**INDEPENDENT
ADVISORY PANEL FOR
UNDERGROUND MINING**

**DENDROBIUM EXTENSION
PROJECT**

SSD-8194

October 2020

Figure 1: A section of the proposed mine layout for Area 5 showing the three different types of setbacks on which the mine plan is based.

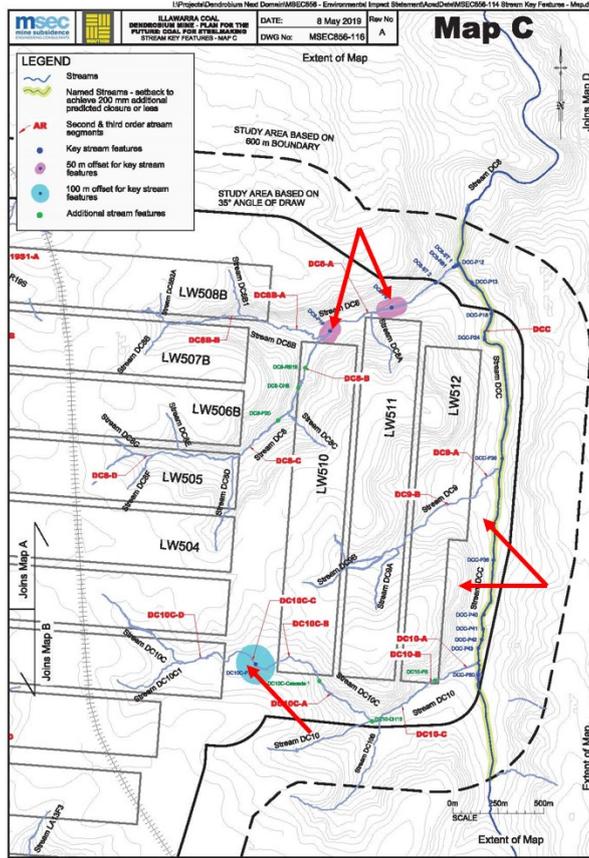
South32 proposes to remediate key stream features, where subsidence has resulted in physical damage (e.g. significant fracturing of rockbars that results in surface flow diversion and draining of pools)¹⁵. Examples of the three types of setback distances for future reference are shown in Figure 1 for the north-east section of Area 5 and in Figure 2 for the southern section of Area 5¹⁶.

The locations of the key stream features identified by South32 on Donalds Castle Creek are shown in Figure 1. Predicted valley closure for each of these features is plotted in Figure C.07 of the Subsidence Assessment and reproduced in Figure 4 of this review. The Figure illustrates the variability in valley closure along the length of the stream and therefore, the variability in the risk of fracturing rock bars. The use of a fixed threshold value of predicted valley closure (e.g. 200 mm) to assess the risk of fracturing may overestimate the risk for those rock bars associated with low values of predicted valley closure well below threshold (e.g. \leq 100 mm). On the other hand, it could underestimate the risk for those rock bars with predicted valley closure values that are close to threshold (\sim 200 mm) if they have site-specific physical attributes conducive to fracturing. In that circumstance, it is possible that all of these rock bars in the affected area rather than just a percentage of them, could experience Type 3 impacts.

Figure 3: Relationship between predicted total valley closure and proportion of rockbar controlled pools that have experienced Type 3 impacts as at 2009 and also as at 2019.

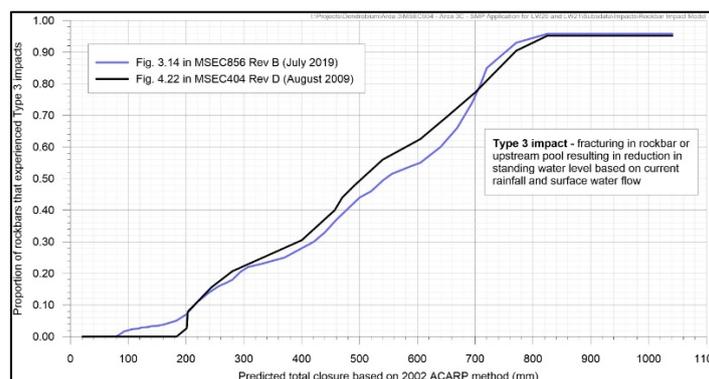
The responses reflect an inconsistent and inaccurate interpretation of the relationship plotted between predicted valley closure and the proportion of Type 3 impacts recorded in the Southern Coalfield. The relationship shown in Figure 3 constitutes a frequency diagram of outcomes recorded across the Southern Coalfield. It neither represents the probability of a Type 3 impact occurring at a specific site nor the proportion of pools along a specific section of a stream that may experience Type 3 impacts.

Figure 4: Extract showing predicted valley closure for pools along Donalds Castle Creek.

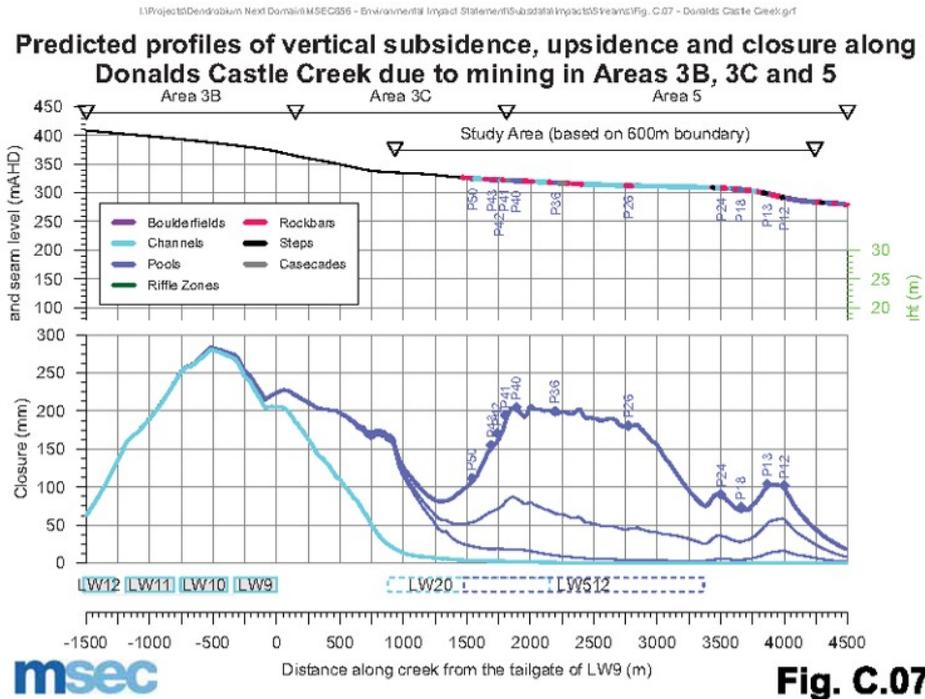
Without the benefit of a site inspection²² and site specific geotechnical assessments, the Panel cannot form a view at this point in time on the likelihood and consequences associated with Type 3 impacts in Areas 5 and 6. Likelihood may or may not be greater than predicted in the EIS.

Figure 5: Ranges in predictions of valley closure for key stream pools on drainage lines plotted on MSEC rock bar model.

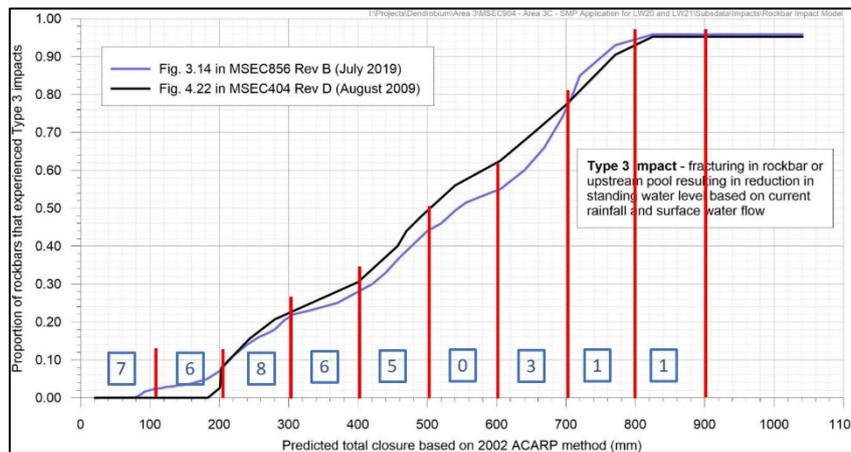
The Panel has referred to graphs of predicted valley closure in Figures C.05 to C.17 of EIS Appendix A to estimate closure values at key stream features on drainage lines. The predicted valley closures for these pools have been plotted on the rock bar model in increments of 100 mm of closure, as shown in Figure 5. Notwithstanding the potential limitations previously noted with predicting site specific likelihoods of Type 3 Impacts from this model, it can be concluded by weighting the number of pools by the likelihood of Type 3 impacts that around 10 of the 37 controlling rock bars are expected to experience Type 3 impacts resulting in loss of pool water.

While this analysis is helpful, it does not provide insight into the consequences associated with the impacted pools. Hence, the Panel repeated the risk assessment process that was applied to pools on Donalds Castle Creek (Table 1), using the same consequence threshold values. The outcomes are shown in Table 2 and flag that the exceedance of the threshold risk levels assumed by the Panel are confined to pools on drainage line LA13 (for pools P4 and P17), in the region where the 100 m diameter setback distance for pools has already resulted in a disruption in the continuity of longwall panels, as shown in Figure 2. Thus, the process gives direction to and aids in objectively assessing environmental impacts and identifying controls and residual risks to inform decision making.
